Central Valley Regional Water Quality Control Board
3/4 June 2026 Board Meeting

Response to Written Comments on
Tentative Waste Discharge Requirements for
City of Manteca
Wastewater Quality Control Facility
San Joaquin County

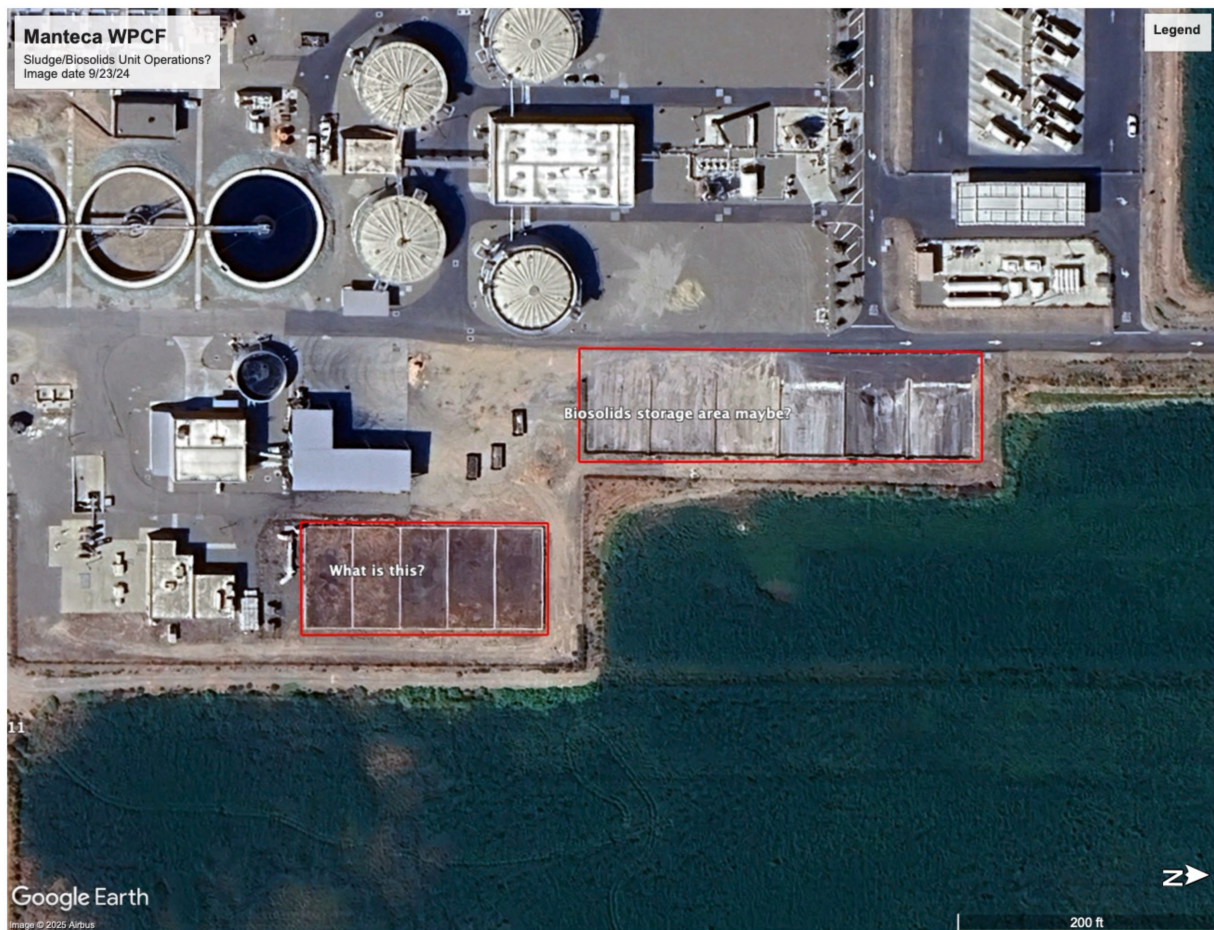
A Google Earth image shown below from 23 September 2024 shows areas of possible sludge drying beds or biosolids storage areas on the Facility property not identified on the Facility maps.

Identify the areas outlined in red on the Google Earth image.

Central Valley Water Board staff clarify that the lower left area outlined in the image is the biofilter chambers for the headworks of the Facility and the upper right area outlined in the image is concrete paved storage areas used for excess biosolids, if the main covered biosolids storage area (the sideways “L” shaped building in the image) is full prior to pickup and disposal by Synagro.
